Initial Submission in response to QR's AU3 Access Undertaking

2 February 2024

This submission is provided in relation to Queensland Rail's (**QR**) 2025 draft access undertaking (**DAU3**) on behalf of Yancoal Australia Limited (**Yancoal**) in its capacity as operator of the Cameby Downs mine, located on QR's West Moreton rail network (shown below):¹

Figure 17: Indicative West Moreton System Reference Tariff Movements from AU2 Tariff

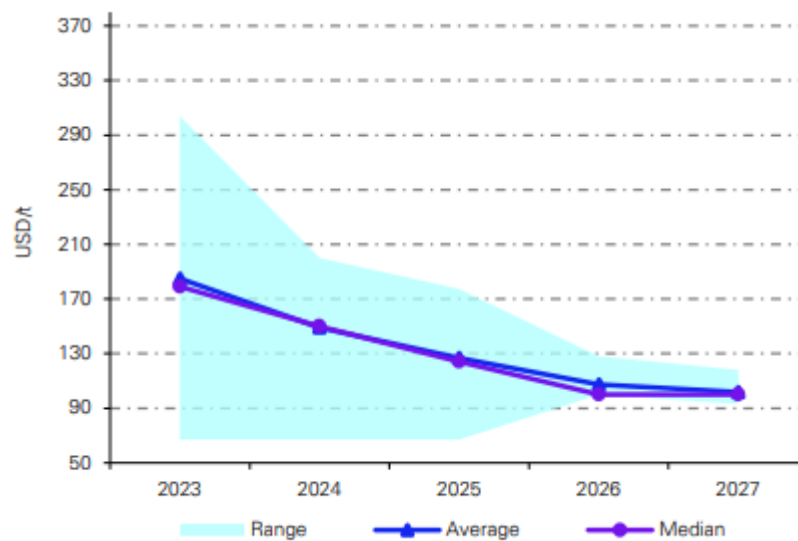
However, as shown in the graph below⁶ factors such as the higher proposed WACC, extensive capital expenditure program, higher operation and maintenance costs, and QR's accelerated depreciation proposal have resulted in a similar building blocks tariff which is materially higher tariff than the previously assessed affordability tariff (even accounting for escalation to FY\$26 - see red line added to the graph below), even under a 9.6 Mtpa high volume forecast.

While the forecast volumes may have changed, Cameby Downs' profitability and break-even point remains basically the same as it was at the time of the AU2 decision.

Accordingly, Yancoal submits that it should be a major source of concern when the tariff now proposed is significantly more than the previous reference tariffs set having regard to the maximum tariff that would be affordable before mines would cease operating.
